File No. : D111118

Project: Jasper Group Inc. Office
Municipal Location: 201 Raglan St
Agent: Jasper Group Inc., Darren Lougheed
Civil Engineer: Crozier & Associates, Jon Proctor
Landscape Architect: Landmark Group
Architect: Peter Archer & Associates, Architect

Development Meeting Technical Report of Compiled Comments

D111118 Jasper Group Inc. Office

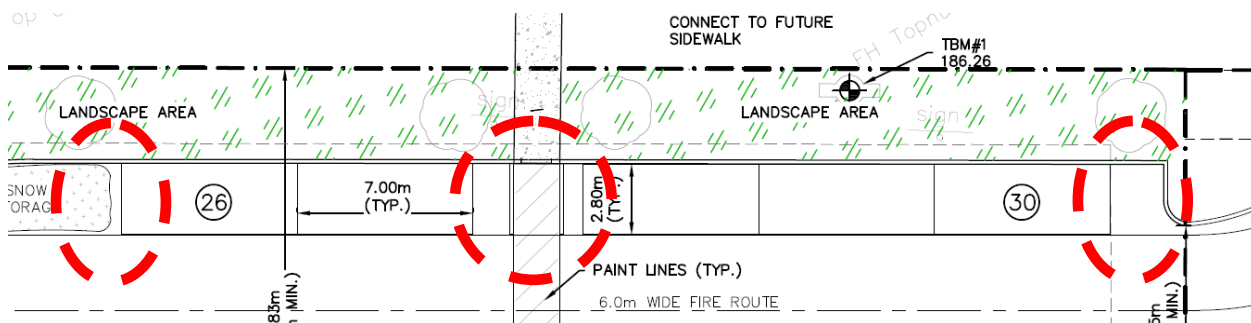
1. The minimum parking required in C5-3 is 53 spaces. If 53 spaces are not to be provided (30 spaces are shown) a zoning by-law amendment is required to eliminate the medical use permissions from the C5-3 zone to justify the parking space reduction from 53 spaces to 30 spaces. At this time the zoning by-law amendment has been submitted, but has yet to be enacted and passed by Council.
2. In the C5-3 zone the minimum front yard and exterior side yard setback required is 3.0 m. Crozier Drawing 101 has identified that the minimum is 6.0 m which is not correct. Revise the “6.0 m” to read “3.0 m” including in the site statistics chart. Also the label of “loading space” on the drawing can be revised to “delivery space”.

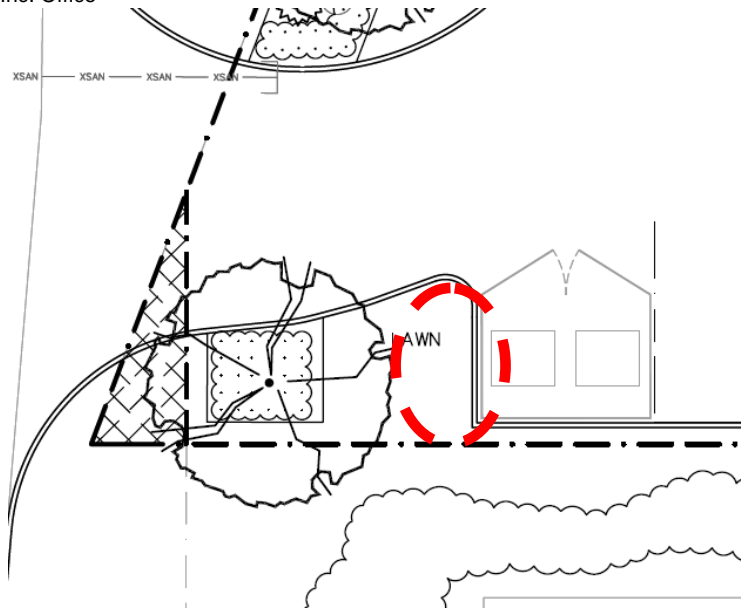
- Section 6B.17 (pg.6-7) Parallel parking spaces to be bounded by curb bulb-outs (see below).
